From: Breen, Mike J
Sent: Wednesday, 7 May 2014 2:28 PM
To: Carson, Lucia
Subject: RE: Pedestrian Assessment for Rivett Block 18 Section 28
Attachments: 20140507151916883.pdf

**PROPOSED SERVICES PLAN
RIVETT SECTION 28 BLOCK 13**

Drawing Number
MMD-311006-C-DR-C005-SP-0002

Project Description Rivett Section 28 block 13 - Pedestrian Assessment/Purchase Order No L14362 AUD

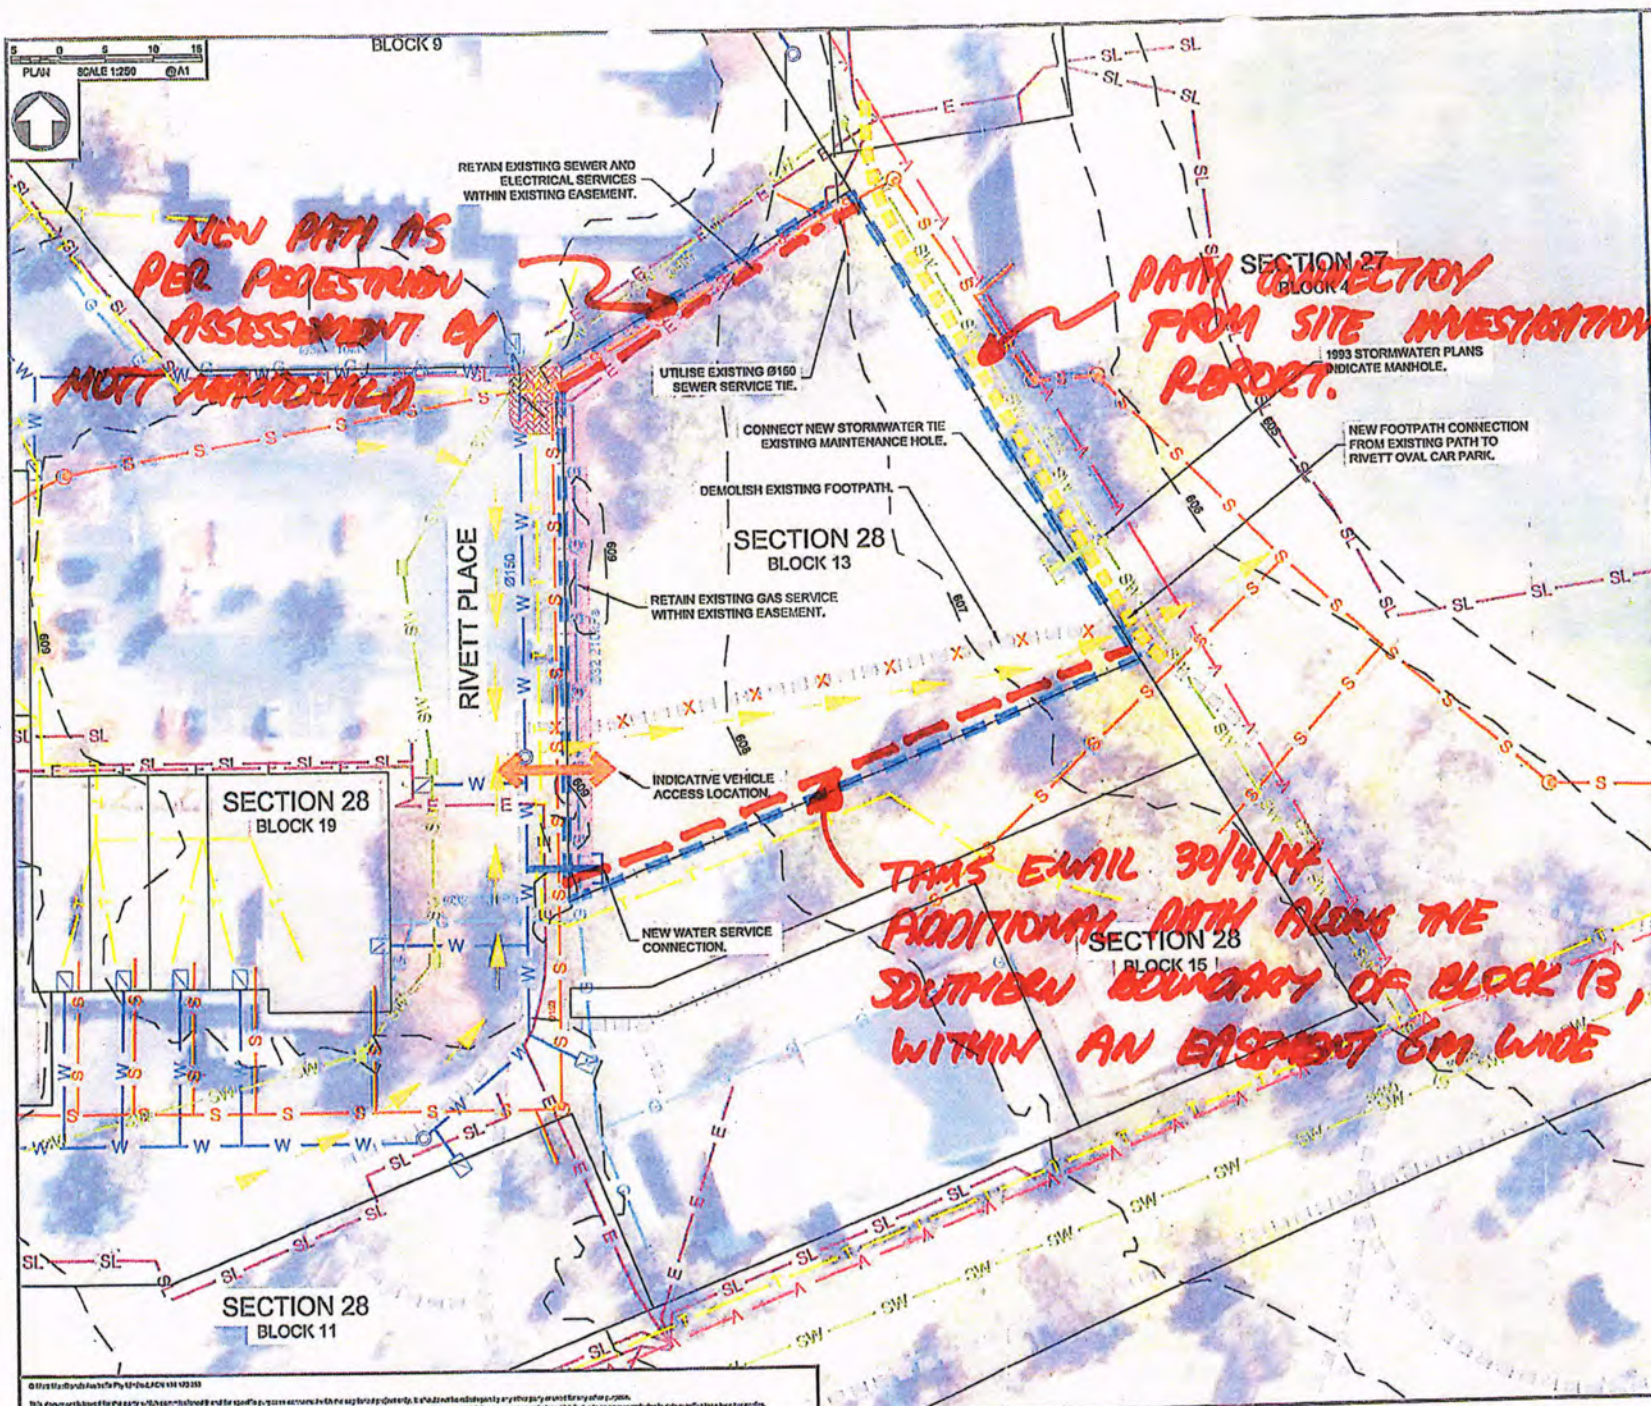
Thank you for advising me of TAMS in principle support of the pedestrian study. Would you please forward a map showing the extent of the new footpaths and their locations in particular the additional footpath to the north which they have requested be located within an easement of a minimum of 6 meters wide. The SIR will need to be revised and TAMS in principle support of the Pedestrian Study included, the costings will also need to be amended.

I have also gone through the original SIR undertaken in 2013. The SIR makes mention of Existing Services Plan and Proposed Services Plan however when checking through the SIR they do not appear to be attached to the appendix. Could you please check and make sure that the revised SIR does include both Existing Services Plan and the Proposed Services Plan which should now also show the new footpaths.

1. The proposed footpath to be along the southern boundary of the block 13. This footpath is additional to the northern footpath and should be located within an easement of a minimum of 6 meter wide.
2. Public consultation for the removal and rearrangement of the footpath.

Thank you for your response. Mott MacDonald have prepared a proposed services plan (refer attached) for inclusion into the Site Investigation report on the following basis:

Mott MacDonald have identified that there is an existing public stormwater line outside the eastern boundary of the Site within adjacent Section 27 Block 4 – Urban Open Space. This existing stormwater line is located on the low side of the Site. It is considered appropriate for the service tie for Section 28 Block 13 to connect into the existing manhole along this line at the lower eastern corner of the block as shown on the proposed services plan attached.

The existing footpath through the Site currently provides access from Rivett shops to the path network within the open space system as well as nearby playground facilities. It is proposed that the existing footpath through the Site be removed and offsite pedestrian facilities be improved by providing footpath continuity to the existing carpark servicing the oval. It is anticipated that the existing footpath south of the development Site could be utilised to access the path network and the playground from the Rivett shops.

An indicative location for vehicle access has been shown on the proposed service plan. This location is clear of the existing 90 degree parking spaces adjacent to the western boundary of the Site. This proposed driveway location is also clear of the circulation isle of the carpark which serves Rivett shops. Note that the indicative location will provide for a similar arrangement to the existing access driveway for Section 28 Block 15 which is adjacent to the Site.

Figure 2.4: Proposed Path Extension (^ South)

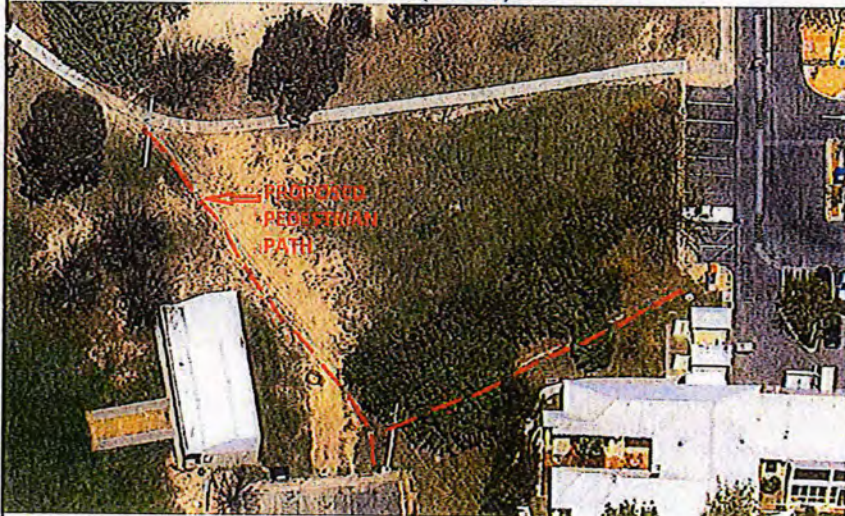
1. The proposed footpath to be along the southern boundary of the block 13. This footpath is additional to the northern footpath and should be located within an easement of a minimum of 6 meter wide.
2. Public consultation for the removal and rearrangement of the footpath.

In addition the offsite pedestrian facilities could be upgraded by providing path connection from the open space path to the existing carpark servicing the oval. This 50m length of path could be aligned parallel and external to the eastern boundary of Block 13.
